AR9100 Soft Switch Modification

Soft Switch Modification Procedure

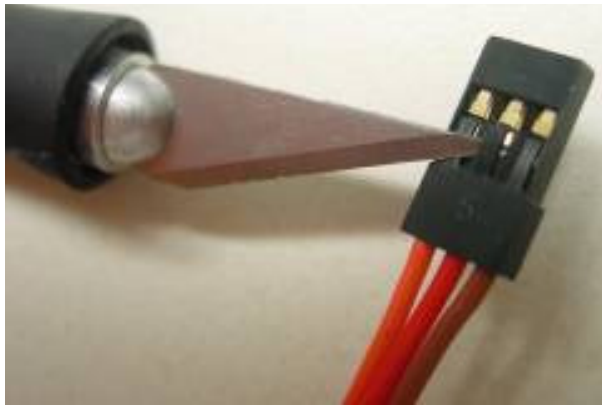
1. Use an X-acto knife to raise the center pin latch.

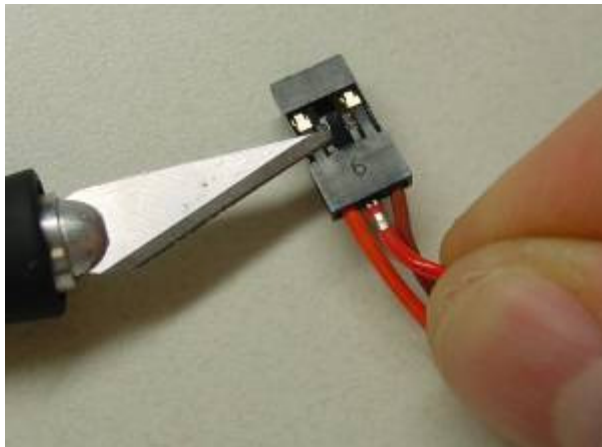
2. Pull on the red wire to remove the center pin from the connector.

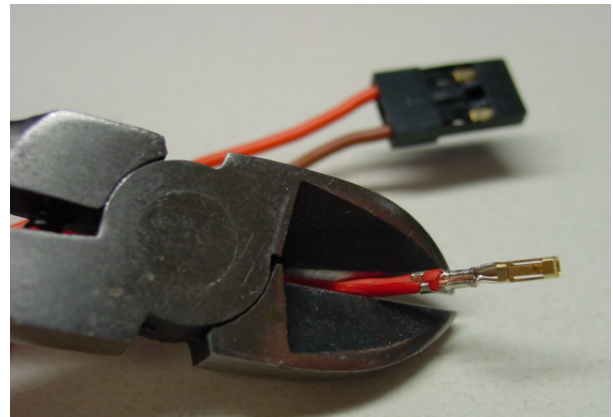
3. Cut the red wire approximately 3-4mm back from the center pin.

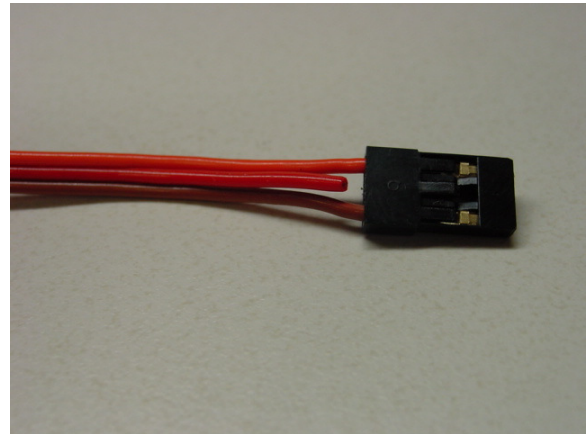
4. The red wire should be short enough that it doesn't fit back into the connector.

Option 2 – Cut Wire

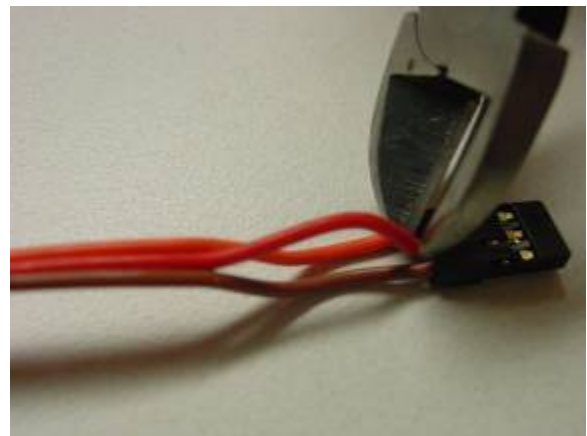
1. Cut the red wire just above the connector.

2. Make another cut and remove a portion of the red wire.
